**ROCKHAMPTON REGIONAL COUNCIL**  
**AMENDED PLANS APPROVED**  
**25 May 2016**  
**DATE**  
These plans are approved subject to the current conditions of approval associated with  
**Development Permit No.: D/278-2011**  
**Dated: 29 May 2012**

**PROJECT**  
**PROPOSED RETAIL & CHILDCARE CENTRE**  
**LOCATION**  
**MAIN STREET, ROCKHAMPTON**  
**CLIENT**  
**POWERCAT DEVELOPMENTS PTY LTD**  
**TITLE**  
**SITE PLAN**

**INFORMATION RESPONSE**

**DEVELOPMENT PERMIT FOR MATERIAL CHANGE OF USE (SHOP) AND OPERATIONAL WORKS (SIGNAGE – PYLON SIGN)**

**Revised Proposal Plans**  
**Prepared by BEAT Architects**

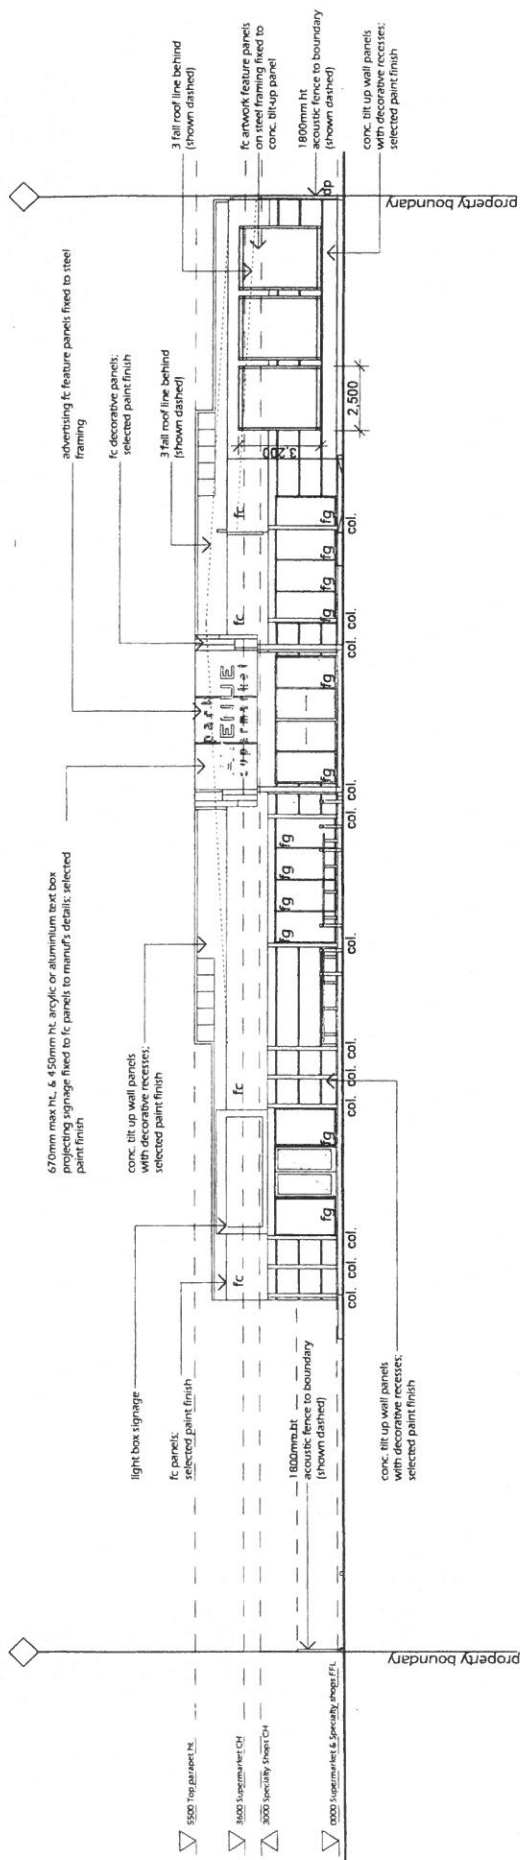
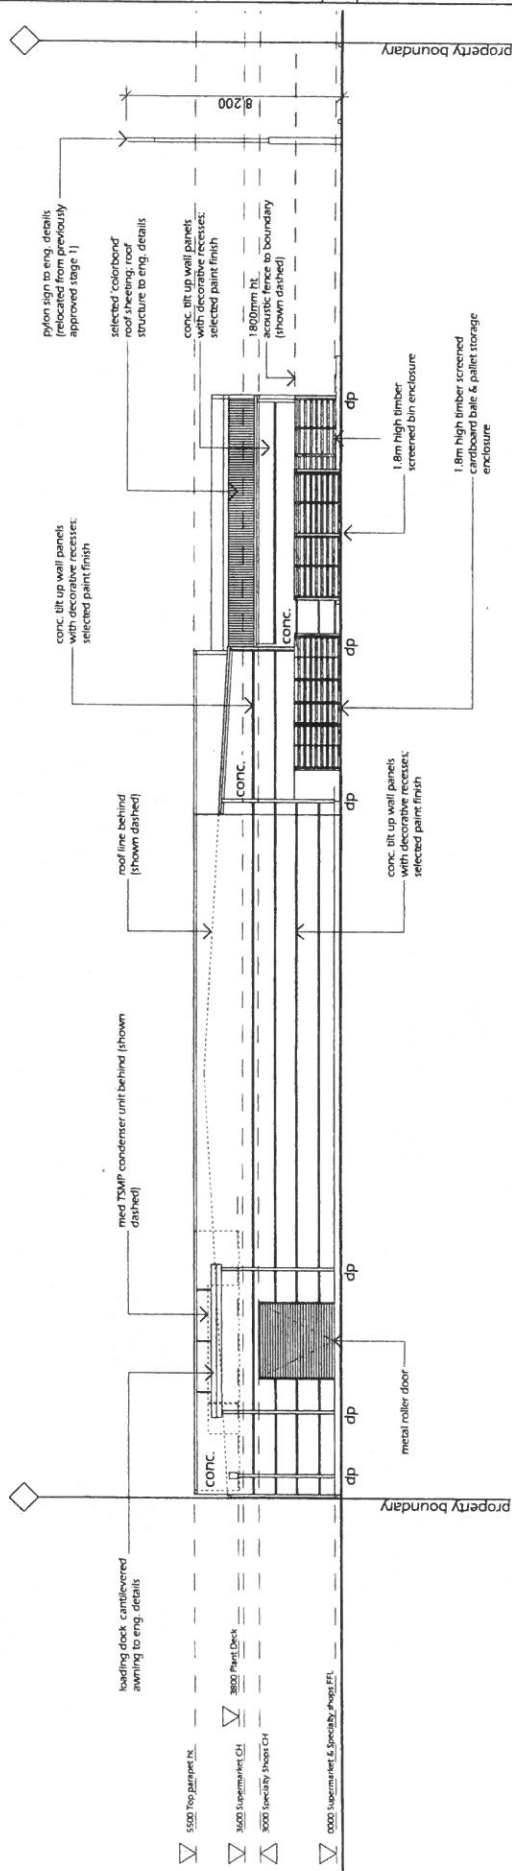
*The building bulk and general appearance of the facade on the southern boundary is dominated by a wall of approximately seventy-four (74) metres in length. Therefore, to properly assess the building design and appearance please provide an amended plan of the South Eastern Elevation of the proposal in a suitable scale and in colour to demonstrate compliance with Performance Criteria P12 of the Activity Centres Code in the Rockhampton City Plan 2005.*

**Response:** As verbally requested, please refer to the rescaled Elevation Plans prepared by BEAT Architects included as Attachment 1. All elevations have now been provided at a closer scale. The NE

elevation (view from the adjacent PA hotel/motel) has a fire-rated concrete tilt-up wall, articulated with downpipes & decorative horizontal rebates. This detail is now evident in the closer scaled elevations.

**Figure 3: Van Manoeuvring in Southern Loading Bay**

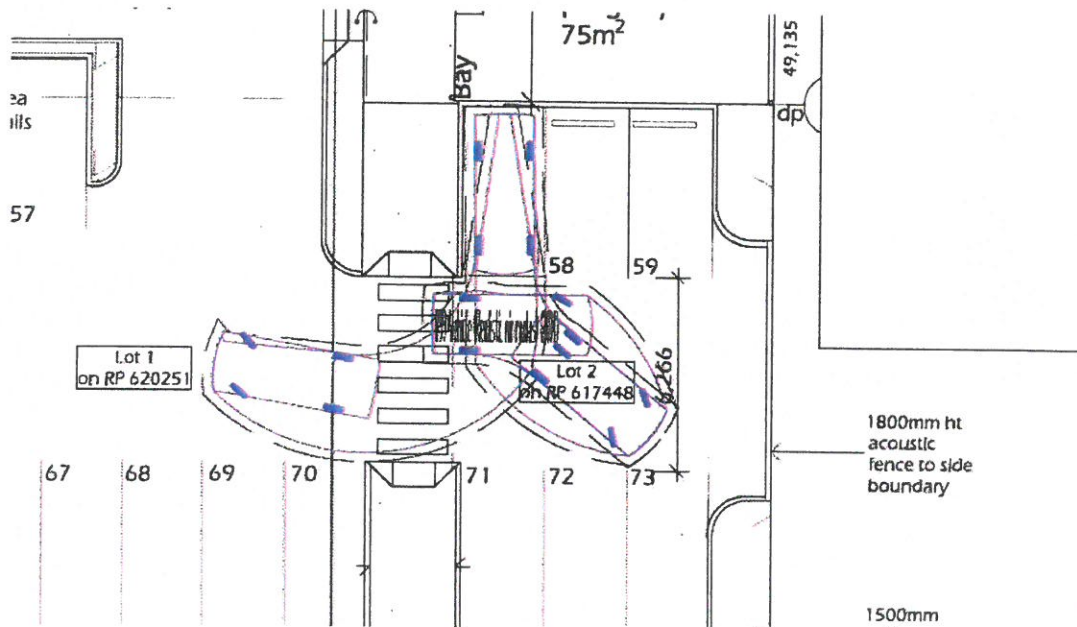
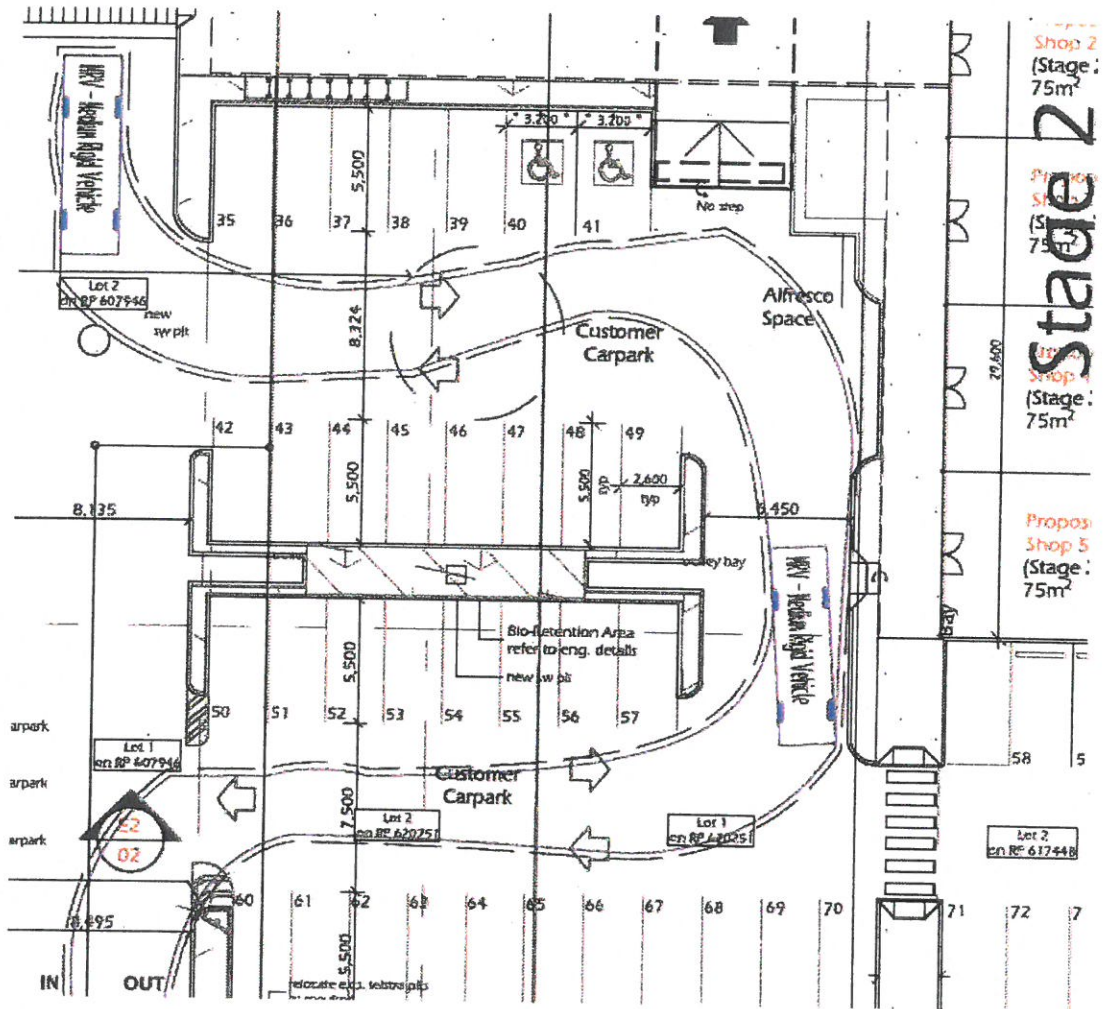
*Please provide dimension/details of loading bays in accordance with Australian Standard AS2890.2 (as amended).*

The southern loading bay is designed with the performance solution of providing access to a van. As shown in Figure 3, below, a van is able to adequately manoeuvre into and from the southern loading bay.

It is anticipated that an R or MR may require access to this location on infrequent occasions. Should a larger vehicle up to an MR, require access this area, they can stand adjacent to Shop 4 and 5, and therefore will not require any reverse manoeuvre within the development. This is shown in Figure 4.

Figure 5: HRV / AV Accessing Site from Haynes Street

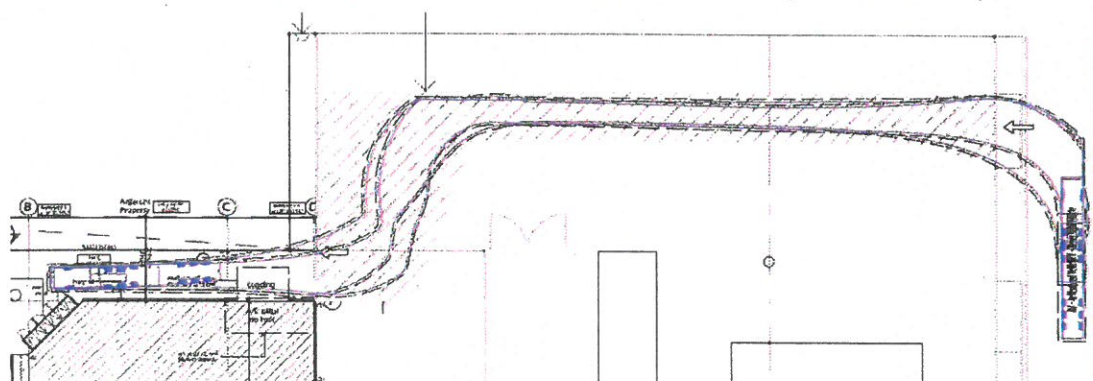
12. Figure A6, dated 12 August 2011 submitted as part of the Traffic Impact Assessment report dated 16 August 2011 for stage two indicates both semi-trailer and Heavy Rigid Vehicles (HRV). Please clarify and amend as necessary.

The service vehicle identified and used in Figure A6 is an RVS. As manoeuvring of an AVE is shown in Figure A5, TTM believe this is suitable.

Figure 5 shows the swept path analysis of an AVE and RVS accessing the proposed loading area from Haynes Street. This swept path analysis that no modification to the easement is required, beyond a slight widening of the Haynes Street access indicated in the previous traffic report.

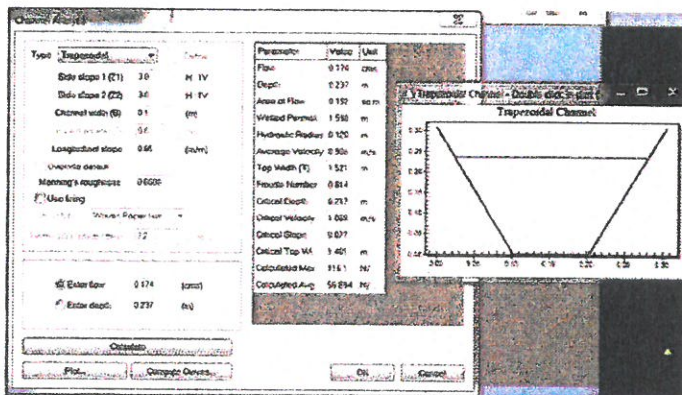
- 15.5 Provide a comprehensive drawing indicating all the associated easements and widths. Any previous drawings must be modified if necessary to include the additional catchment area (part of catchments Pavement A and Pavement B).*

The mitigated runoff from the site is easily contained within the 5 metre easement width, and in fact only requires a channel width of 1.57 metres assuming 1:3 landscaped sides and a conservative value for both the manning's n (0.06) and the longitudinal fall in the channel (0.5%) - refer calculations below

**Item 19**

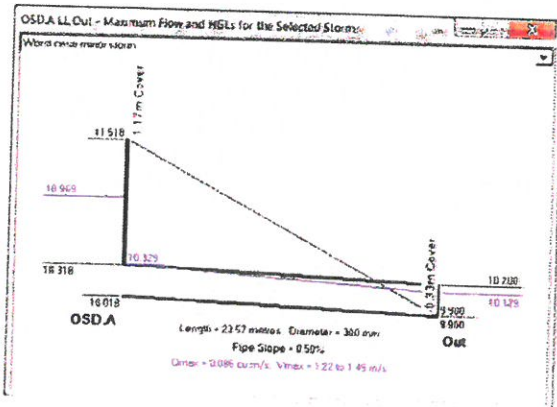
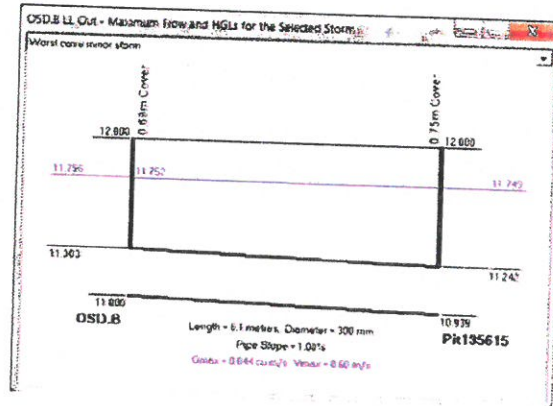
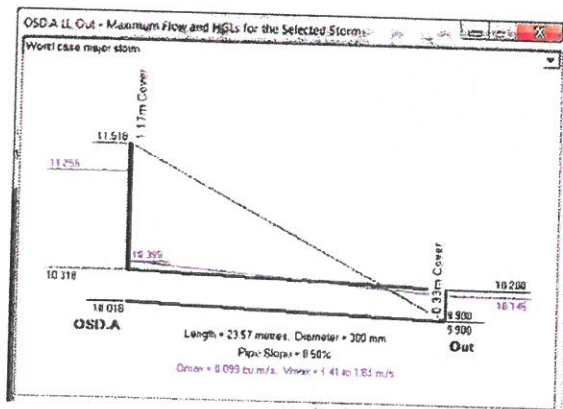
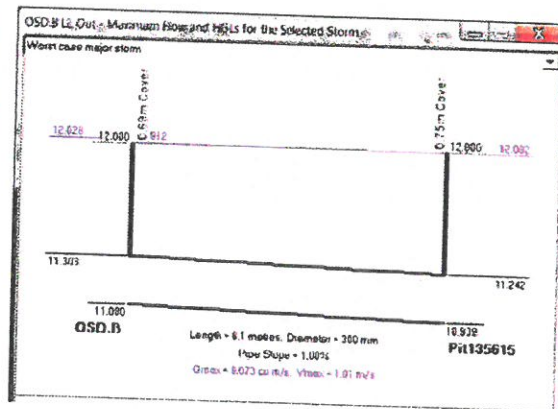
*Please provide cross section details of all detention tanks with inflow and outflow pipe outlets sizes, inverts and chambers (if any). Please provide calculations for the sizing of the outflow pipe outlets of the detention tanks for the predevelopment controlled flow.*

The on-site detention system inflow and outflow pipe sizes are shown on the attached revised C200. We do not understand the query re "predevelopment controlled flow". Assuming this is meant to read "post development controlled flow" then details are provided for the outlets on the attached details. The calculations are from the DRAINS model (which has been modified slightly) below and the input and output data are attached for the major and minor flows.

PIT 17' x 15' TO BIO BASIN B.

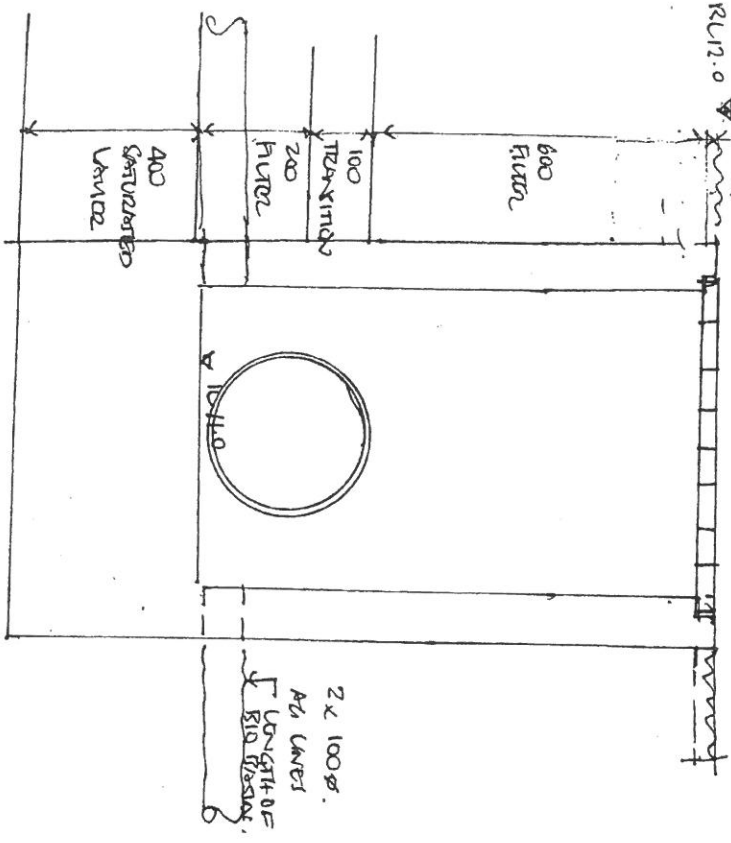
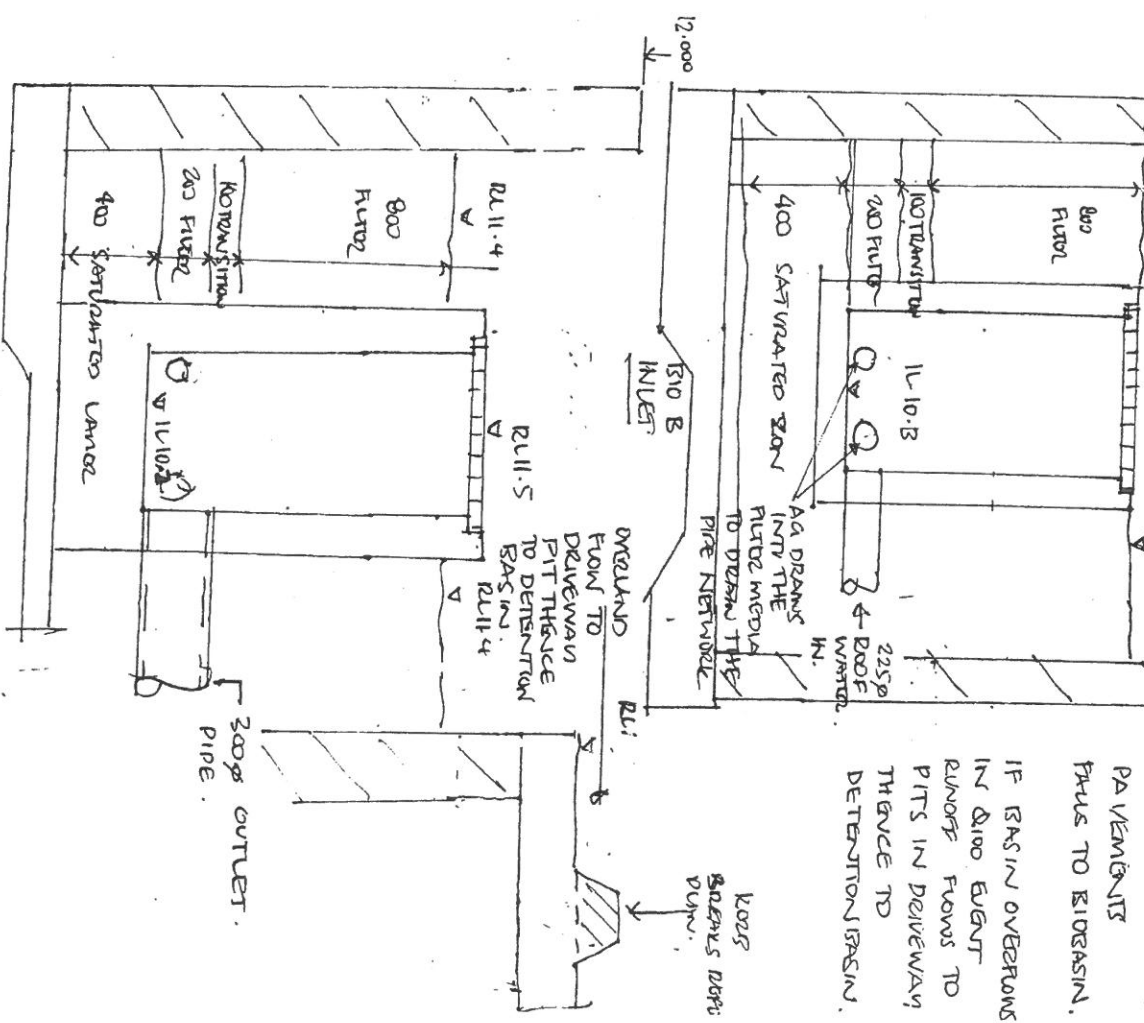
*Please provide cross sections of both overflow pits and surcharge pit located inside the bio - retention basins as indicated on submitted drawing CSK 200 (Issue 2) dated 26 August 2011 with associated levels.*

Refer attached sections through the BioBasin Pits with associated levels. Also attached is an updated version of drawing 211058 C200 showing pipe inverts and surface levels as requested.
